**RELEASED FOR  
 FABRICATION / INSTALLATION**  
 PPPL Drafting:

Oak Ridge National Laboratory managed for the DEPARTMENT OF ENERGY under U.S. GOVERNMENT contract DE-AC05-00OR22725 UT-BATTELLE, LLC, Oak Ridge, Tennessee PROJECT NAME						
NATIONAL COMPACT STELLERATOR EXPERIMENT VACUUM VESSEL PERIOD INSPECTION AND LEAK CHECK ASSEMBLY						
VERSION NO.	PLANT	BLDG	FL	SHT OF	TYPE	CLASS
5	X-10	5700	3	2 19	A	U
RELEASE LEVEL		SE120-004			REV	
Fabrication					2

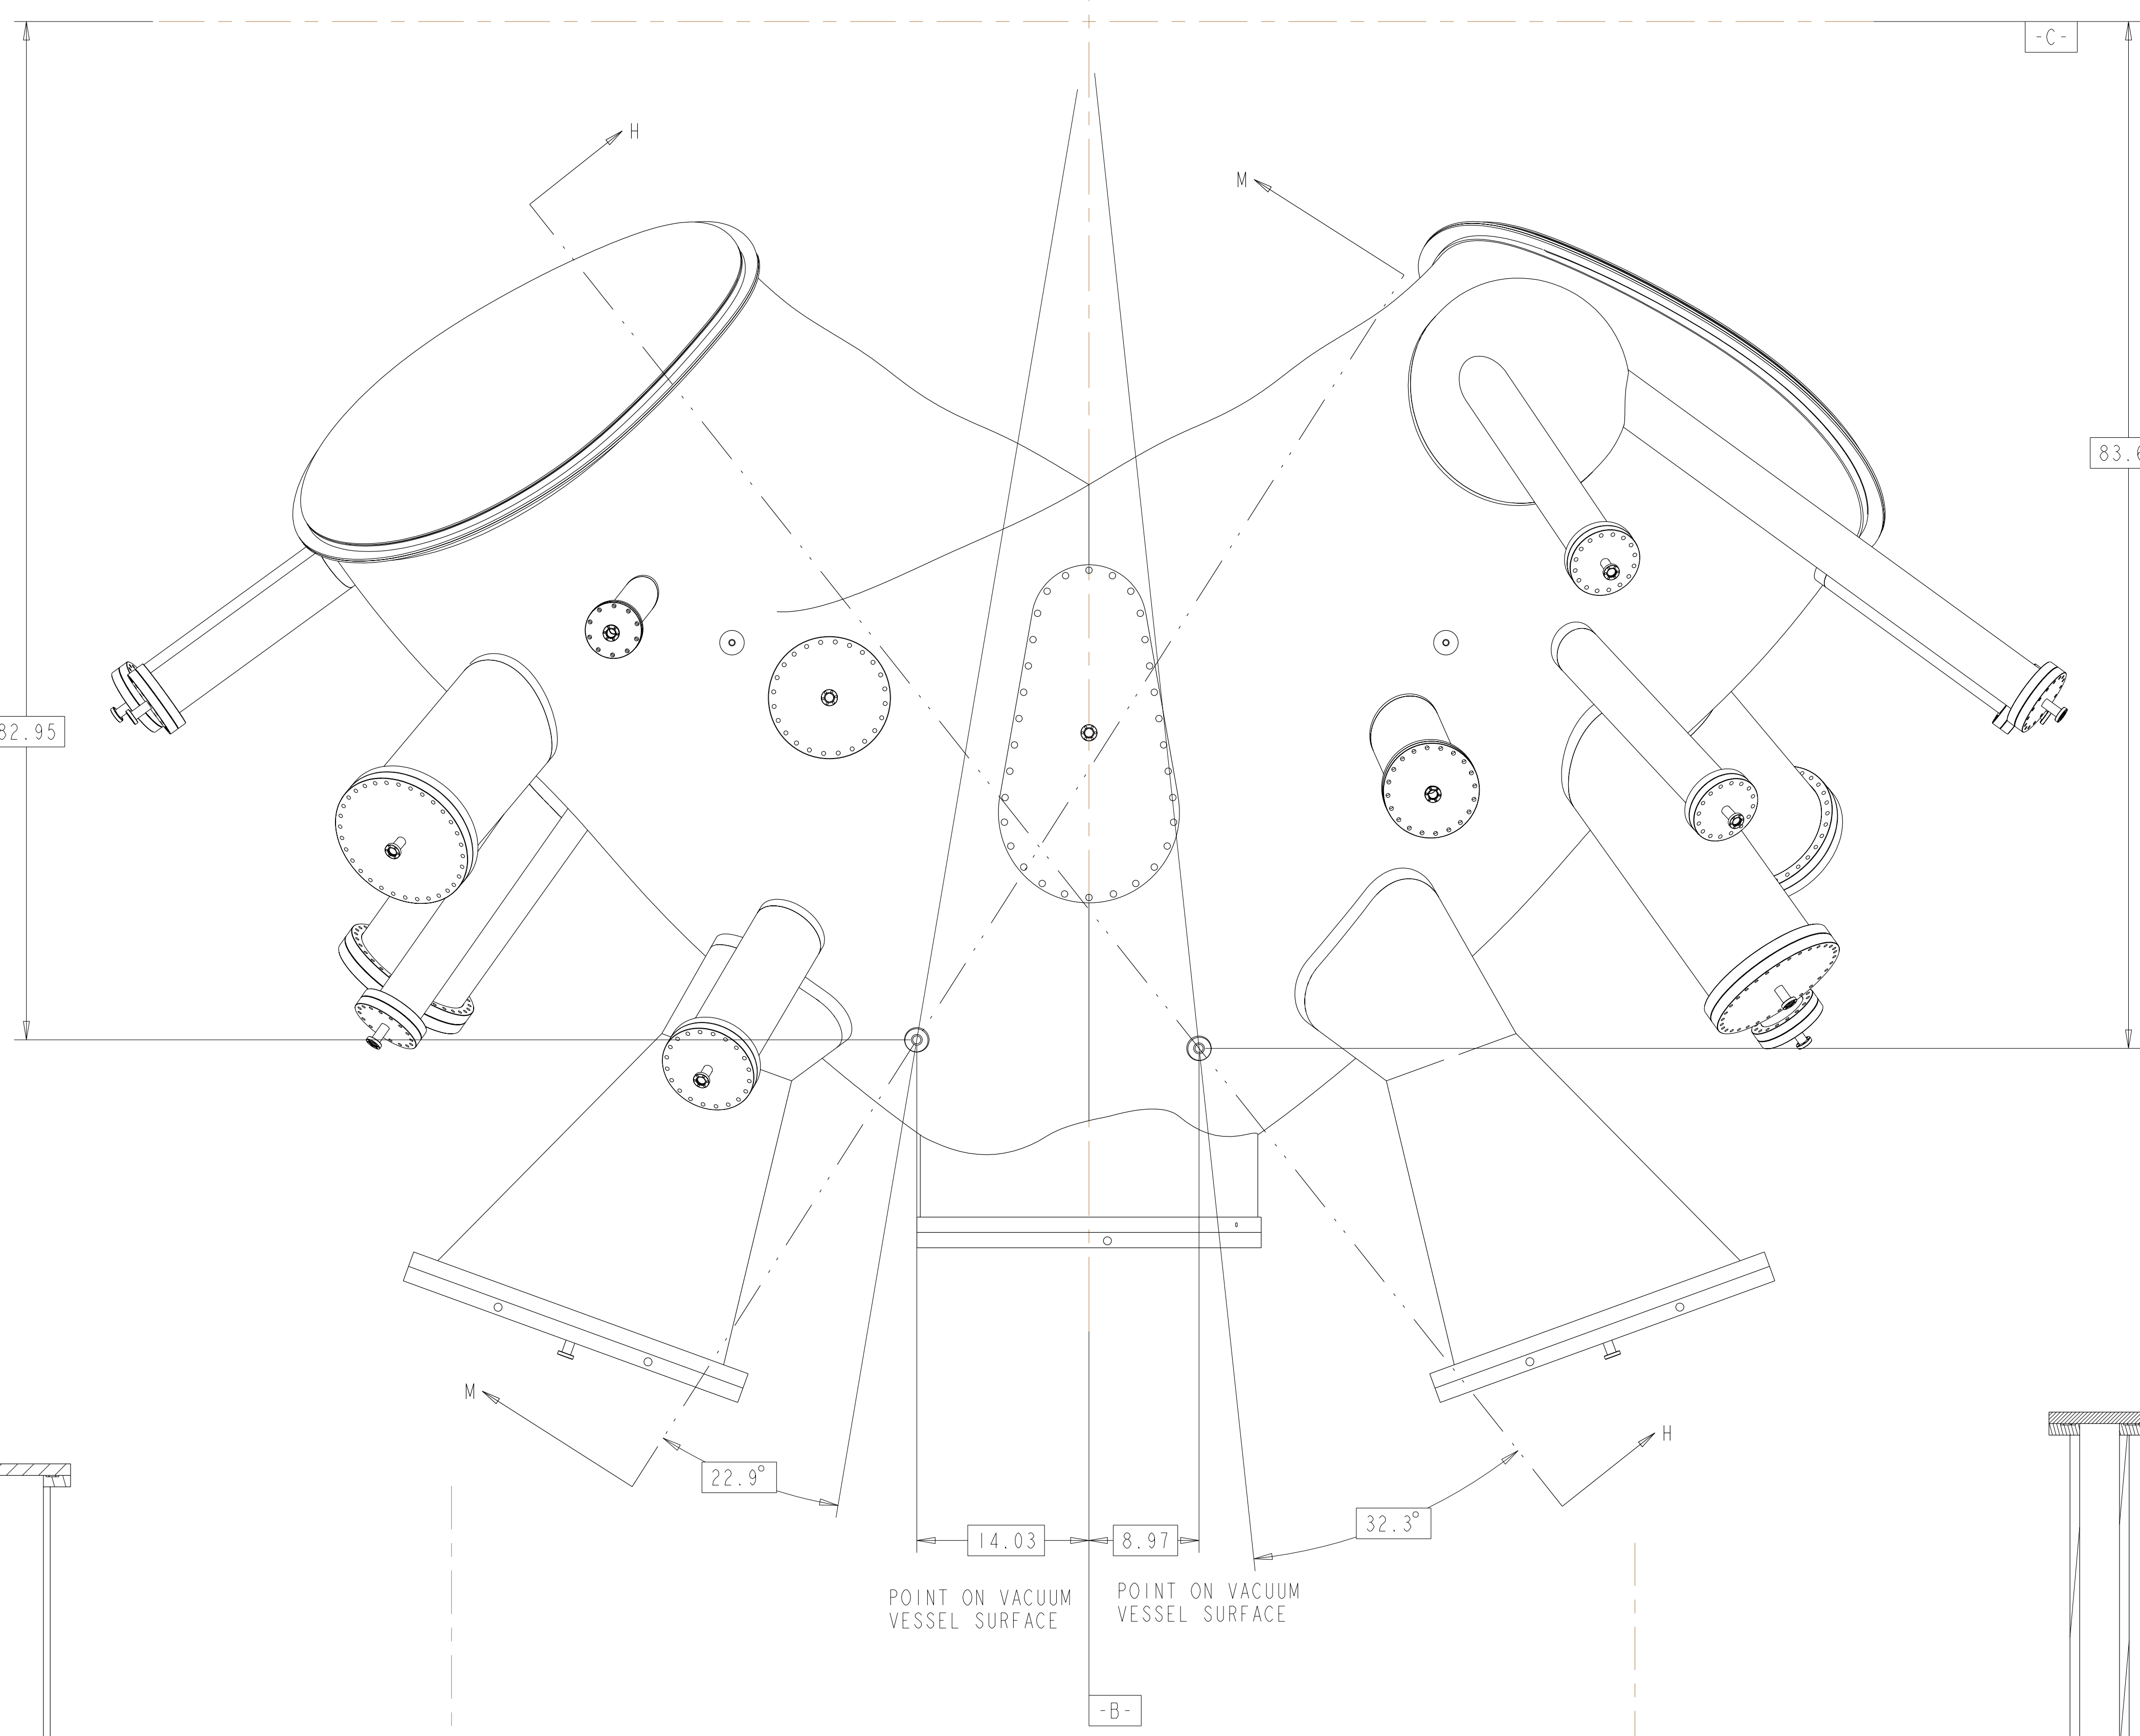
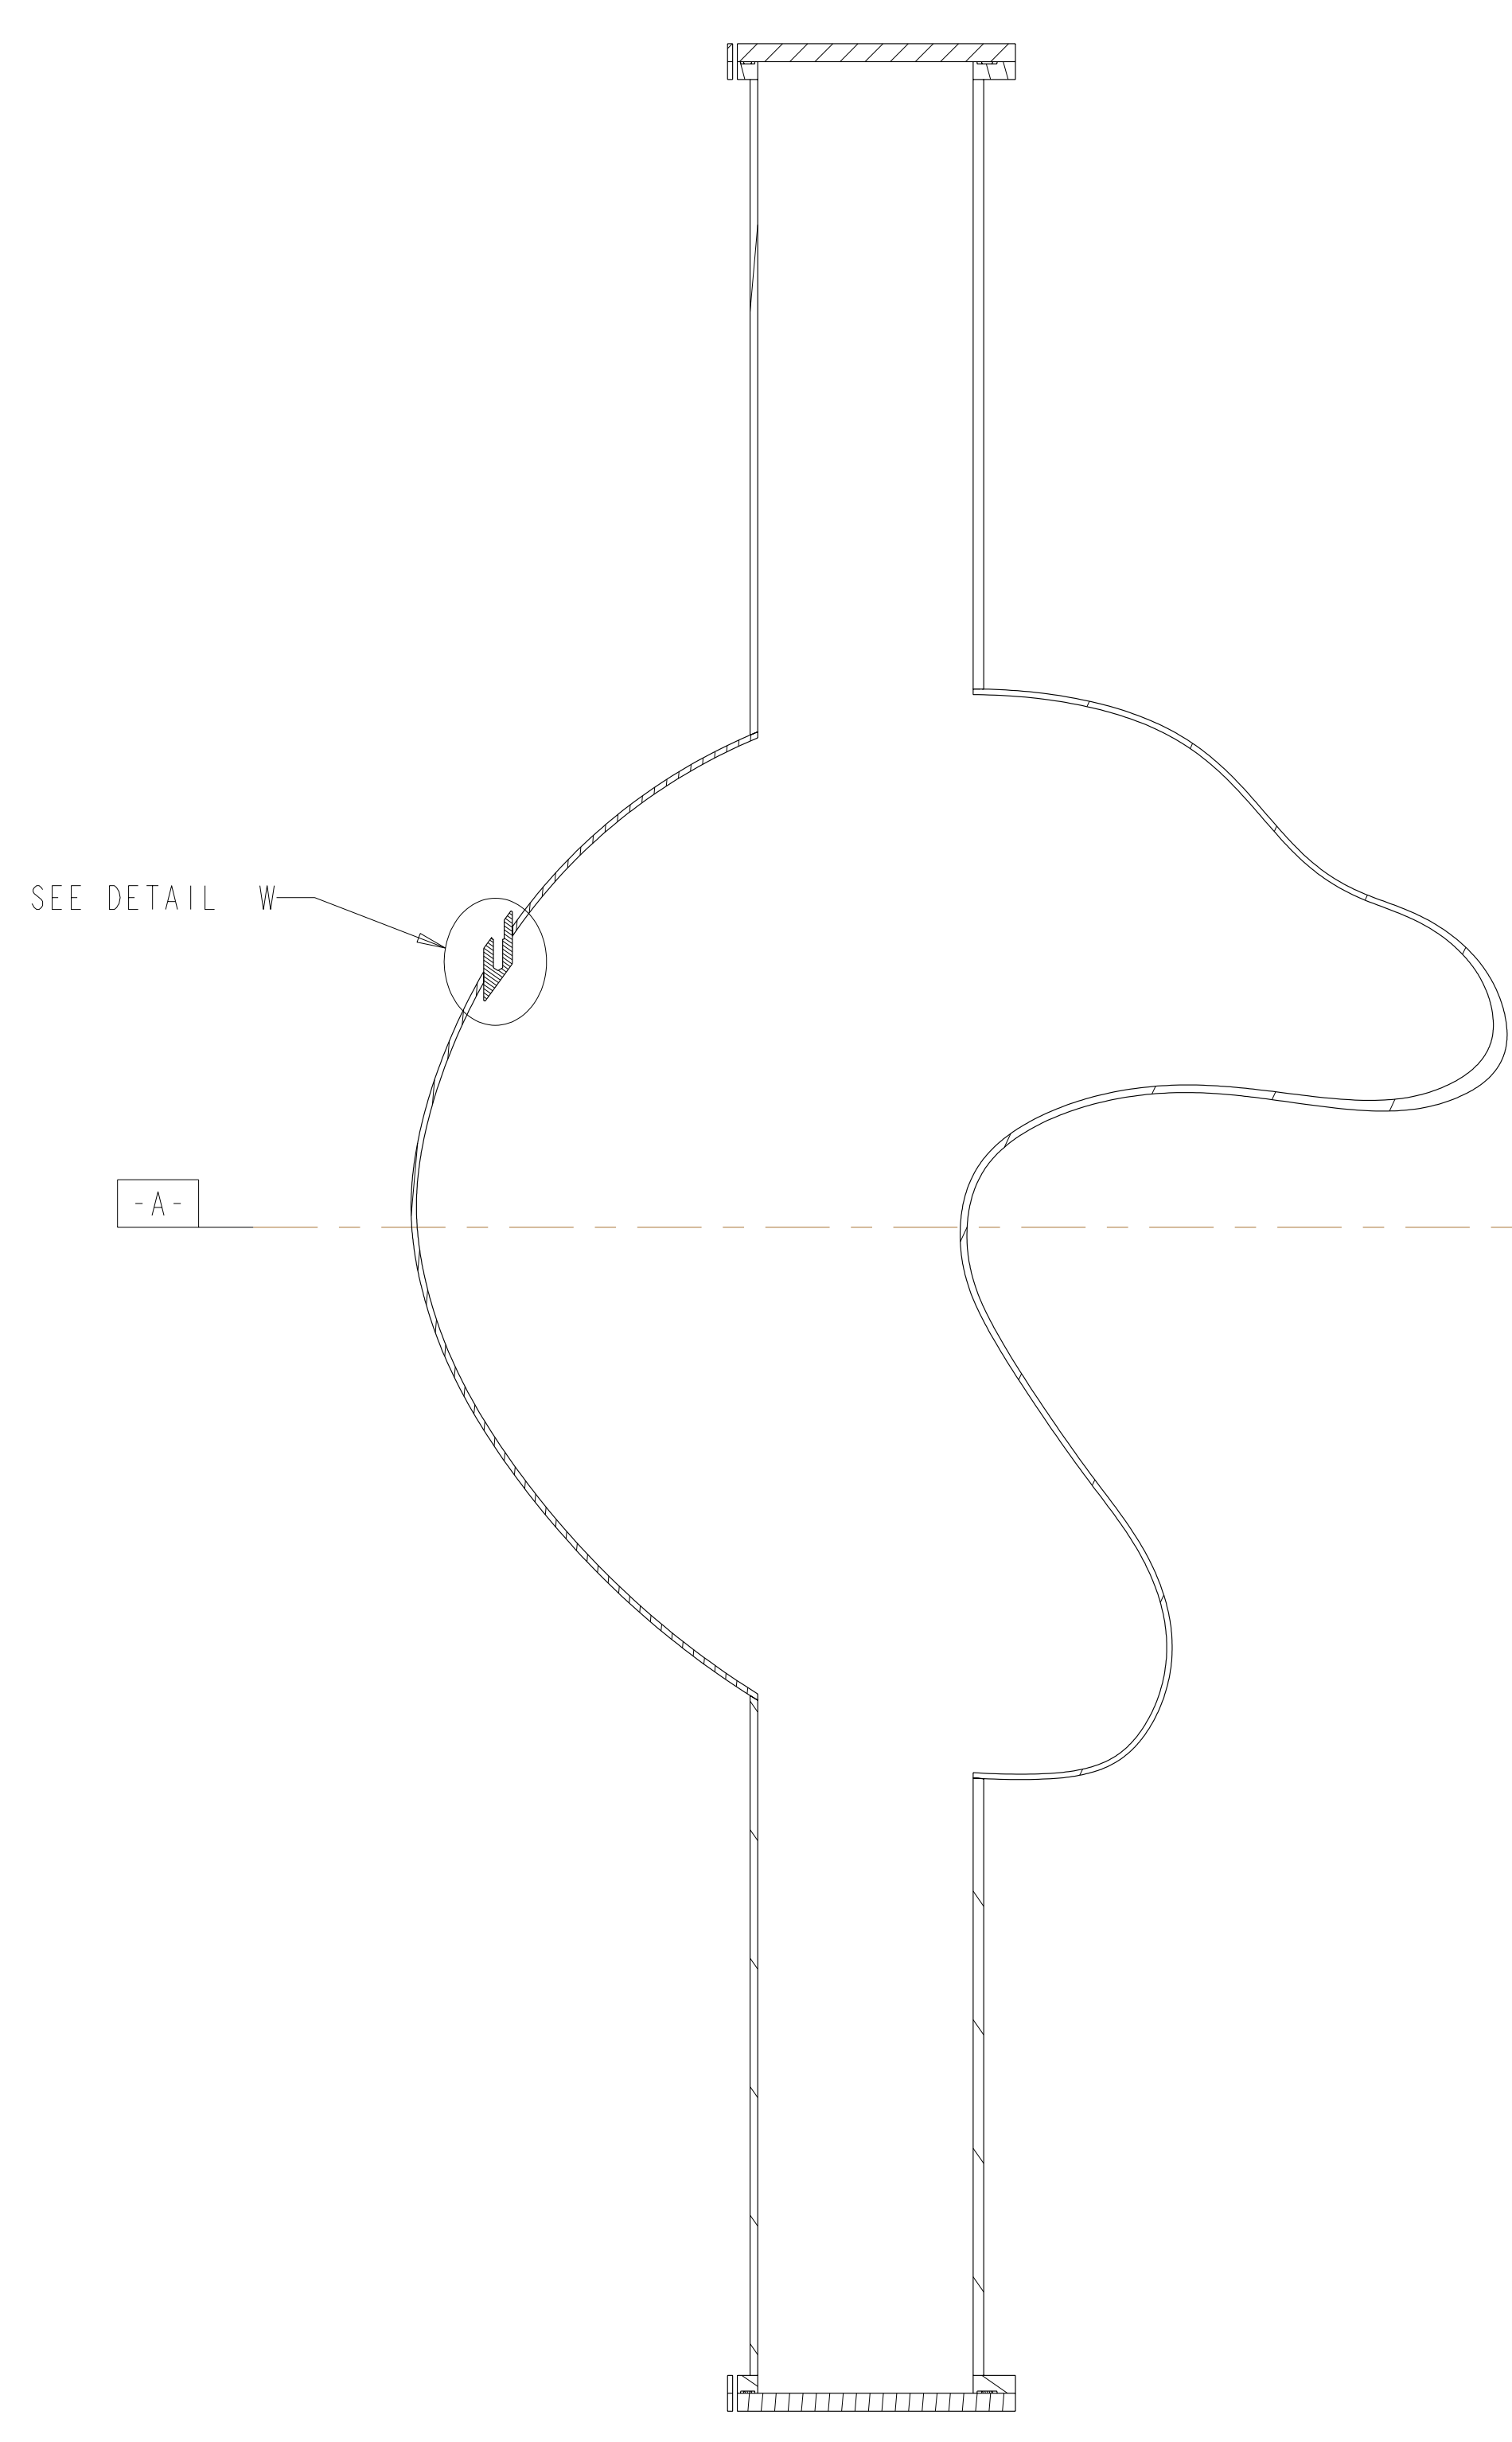
**ECN-5082.** Requirement originally included grooves to facilitate leak checking by vendor. However, vendor elected another means of leak checking and therefore the grooves are no longer required. Specifically, this ECN eliminated the leak checking groove on SE121-014 (Rev 1-c) and SE1221-091 (Rev 0-a). Additionally, this ECN added a missing weld symbol to SE121-004 (Sheets 4 through 19) for joining the port extensions to the vessel (Rev 2-d).  
**(See ECN-5082 for details)**

**Rev 2-e: ECN-5021 (RFD-12-017) approved alternate methods for welding the port extensions to the VVSA (See ECN-5021 for details). - Only applicable to VVSA #3 - VVSA #1 and #2 covered by NCR 19464.**
